534A COUPLER CHANGE 3/2023 – TECHCON SYSTEMS REFERENCE

Reason: the original coupler body is no longer available

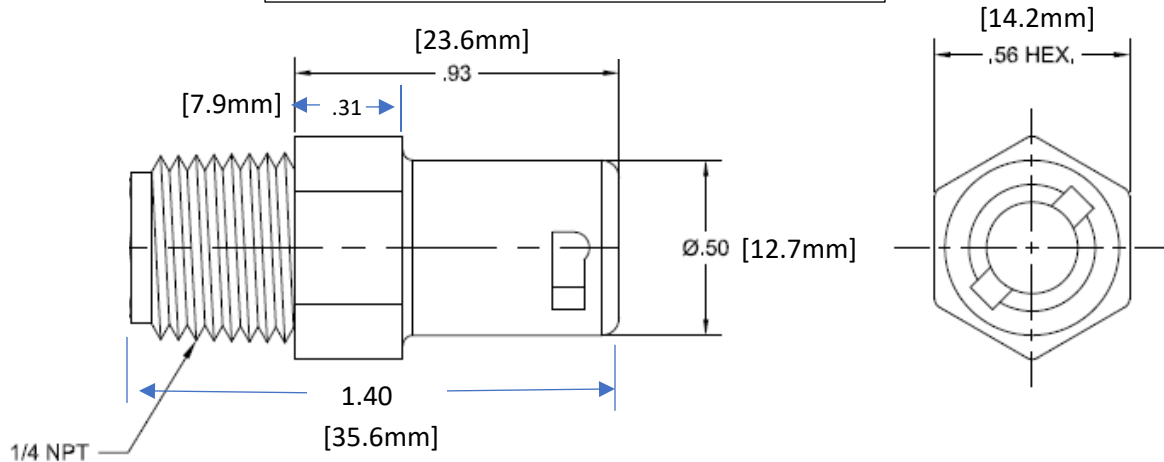
Note:

Previous 534A color white; now current color is black

Body shape slightly different but overall length and most dimensions are same/similar

SAME 1/4 NPT thread and mating 'quick connector' connection

CURRENT P/N 534A part

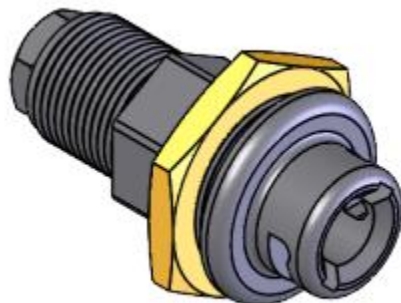
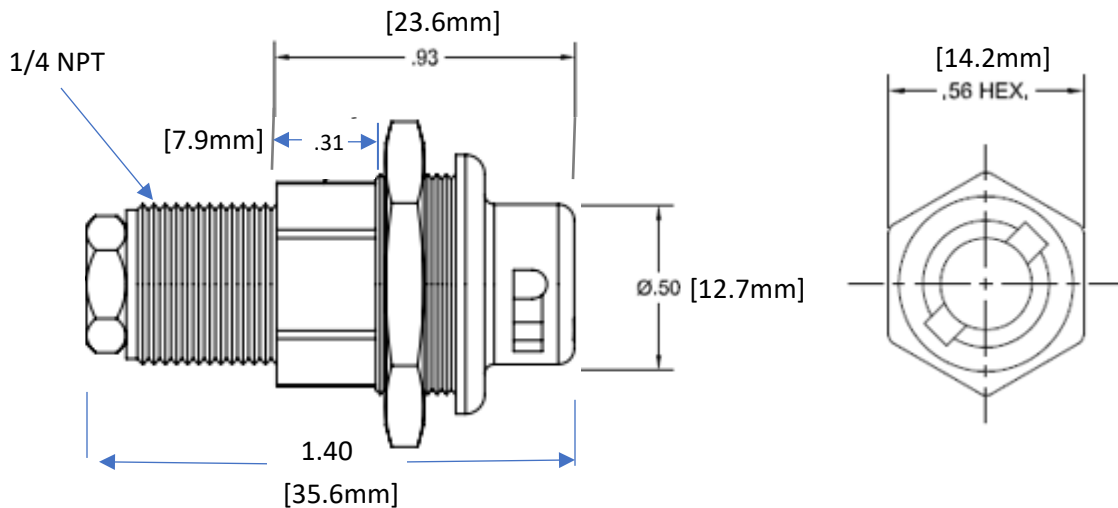
'ORIGINAL P/N 534A body no longer available'
